Tx Jitter specs for Clause 92 and by reference Clause 93

In support of comment 165, and relevant to
comments 223, 227, and 231

Charles Moore Avago Technologies
2013 May 14

Channel for which data dependent jitter was measured

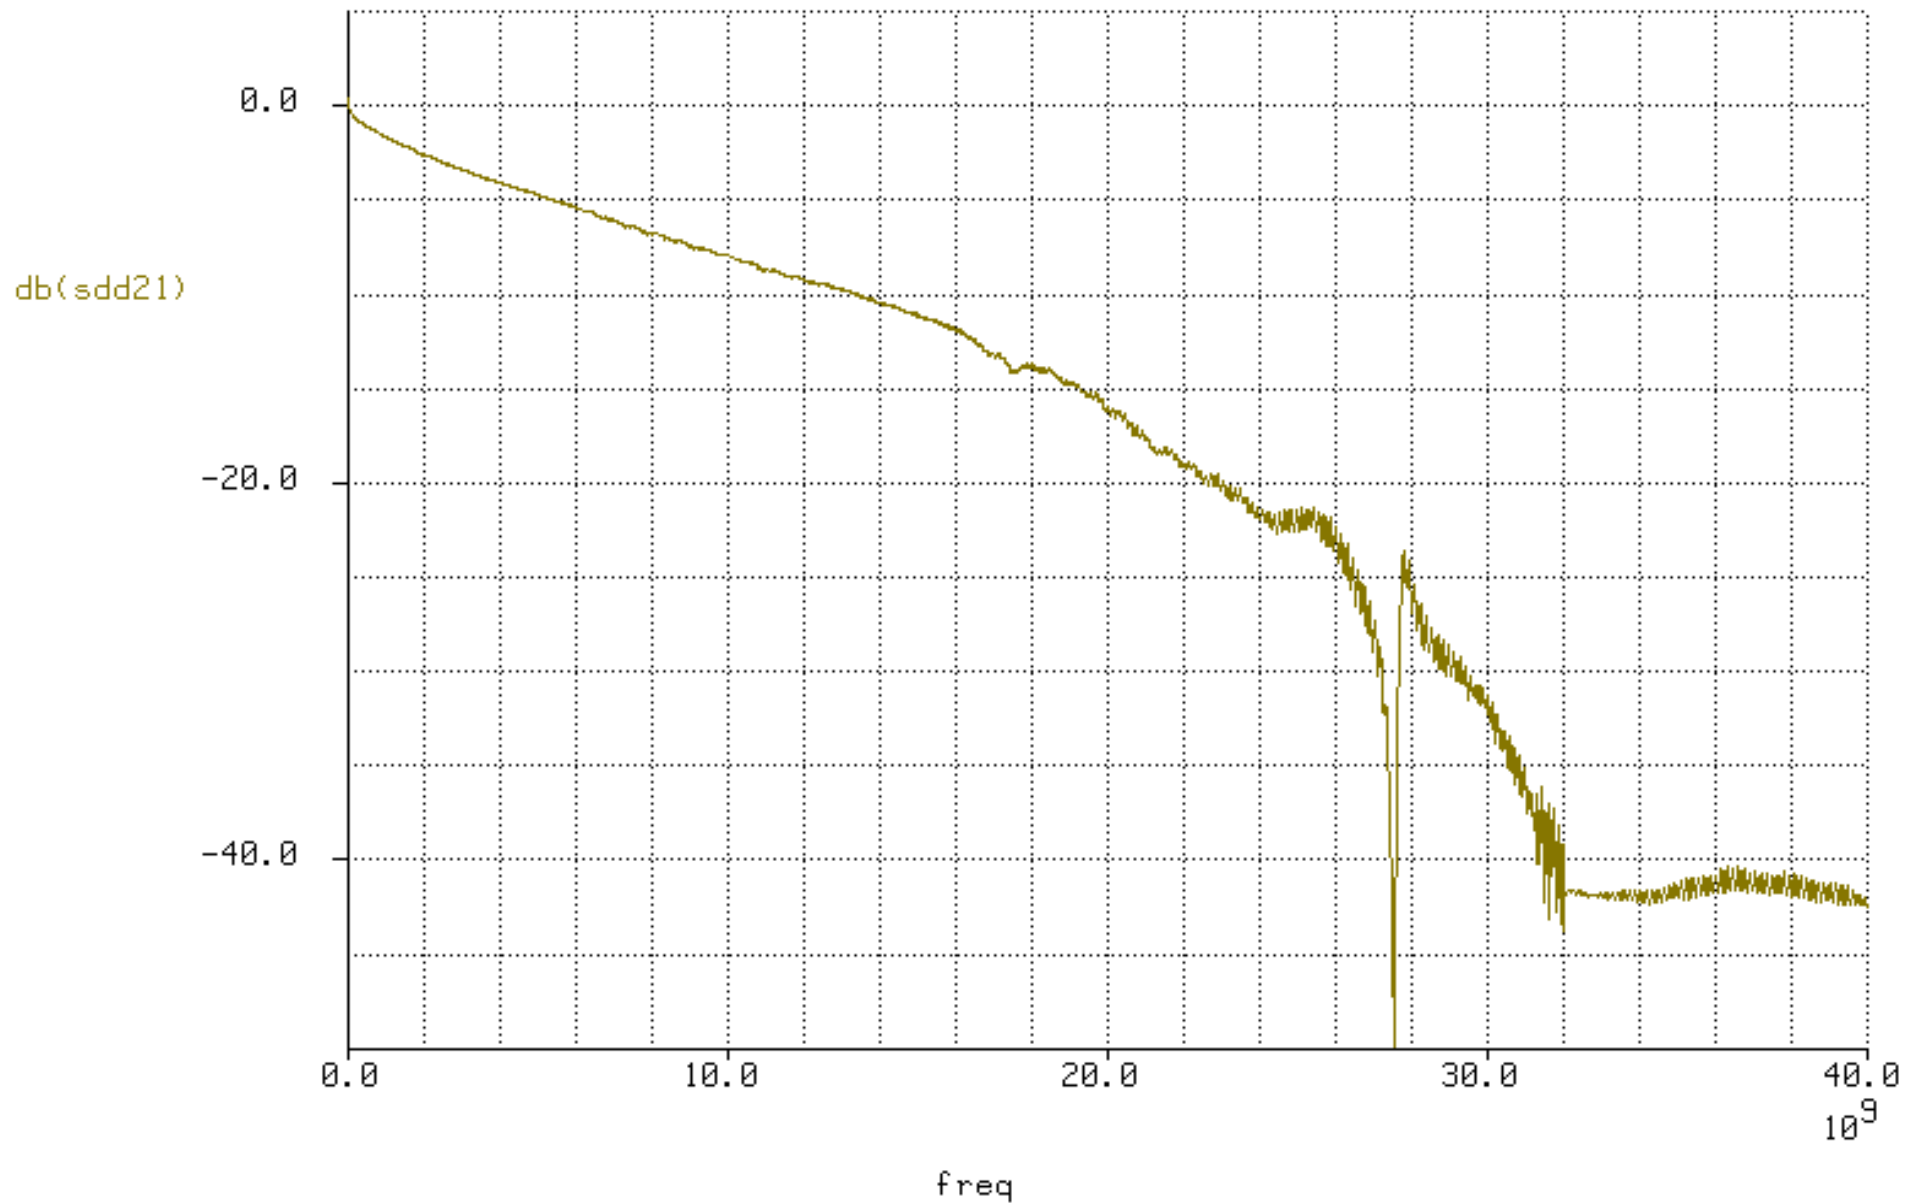
The spec treats data dependent jitter to be a constant, independent of data pattern as the plot in the next slide shows, this is not true

Measured data dependent jitter for PRBS7, PRBS9, PRBS11, and PRBS15 from clean instrument with 3 tap equalizer, plotted on a Q scale along with linear fits.
